Access Compliance Report

Public Rights-of-Way

Intersection ID: N/A	Main Street: TRYON_ST	Cross Street: PUMPERNICKEL_RD	Location: SW
ADA ID: F4B3AC81F062	Ramp Type: PerpDiag	Initial Pass/Fail: Fail	Overall Compliance: No
		Severity Score: 12.5

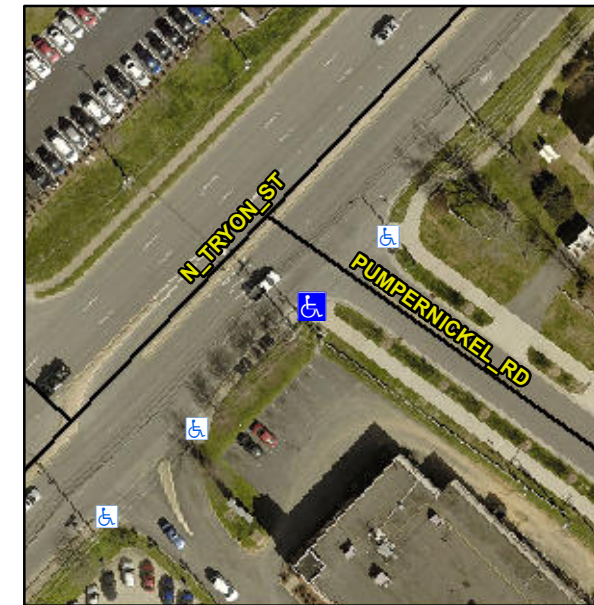
Compliance	Description	Data	Compliance	Description	Data
N/A	Ramp Length (in)	55.0	No	Ramp Slope (%)	9.1
Yes	Ramp Width (in)	48.0	Yes	Ramp XSlope (%)	0.6
N/A	Flare Type LT	N/A	N/A	Flare Type RT	N/A
N/A	Flare Slope LT (%)	N/A	N/A	Flare Slope RT (%)	N/A
N/A	Flare Traversable LT?	N/A	N/A	Flare Traversable RT?	N/A
N/A	Landing Length (in)	N/A	N/A	DWS Provided?	N/A
N/A	Landing Width (in)	N/A	N/A	DWS Contrast?	N/A
N/A	Landing Slope (%)	N/A	N/A	DWS Length (in)	N/A
N/A	Landing X Slope (%)	N/A	N/A	DWS Full Width?	N/A
N/A	Landing Curb? (Y/N)	N/A	N/A	DWS Offset (in)	N/A
N/A	Shared Landing?	N/A			
N/A	Gutter Ponding?	N/A	N/A	Gutter Slope (%)	N/A
N/A	Gutter Lip Ht (in)	N/A	N/A	Gutter X Slope (%)	N/A
N/A	Painted X Walk1?	No	N/A	Painted X Walk2?	No
	X Walk 1 Direction	To E		X Walk 2 Direction	To N
N/A	X Walk 1 Width (in)	N/A	N/A	X Walk 2 Width (in)	N/A
	X Walk 1 Slope (%)	0.5		X Walk 2 Slope (%)	1.6
	X Walk 1 X Slope (%)	1.1		X Walk 2 X Slope (%)	1.9

Possible Solutions:

Remove & Replace Curb Ramp With Two New Directional Ramps or Equivalent.
